MODEL/YEAR MODÈLE /ANNÉE	DATE OF ISSUE DATE EN VIGUEUR	BULLETIN NUMBER NUMÉRO DU BULLETIN
2006-08 CIVIC HYBRID	AUG. 6, 2010	IV-7-10
Rev. Nov. 16/10 - Information marked by black bars

PRODUCT UPDATE: NEW SOFTWARE TO HELP PREVENT IMA BATTERY DETERIORATION

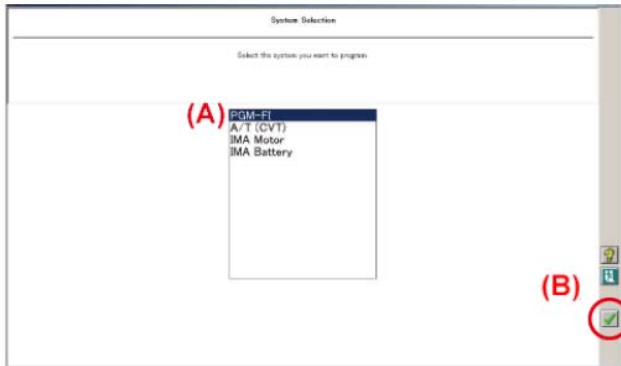
NOTE: After you perform the software update(s), the IMA system will have the following differences. All of them are normal operating characteristics.

- When at auto idle stop the engine restarts sooner. It also now restarts when the IMA battery level gauge reaches two bars.
- Depending on conditions, the auto idle stop may not engage with as many as four bars being displayed on the IMA battery level gauge.
- The IMA system reserves battery power to ensure enough power is available to start the vehicle from a stop and for initial acceleration. This reduces the IMA assist as the vehicle speed increases. This change increases the battery’s stored energy and overall performance.

- The IMA battery level gauge more accurately indicates the battery’s state-of-charge. Customers will also notice that the level bars stay in the middle of the gauge much longer.
1. Using the latest Honda Diagnostic System software check and clear any DTCs present under the PGM-FI system.
 2. Update the PGM-FI software (A) in the ECM/PCM.
Refer to **Tools Bulletin I-2-06, GNA600-VCI Vehicle Communication Interface User Guide For ETech (Revised)**, for instructions on performing Honda control module updates.
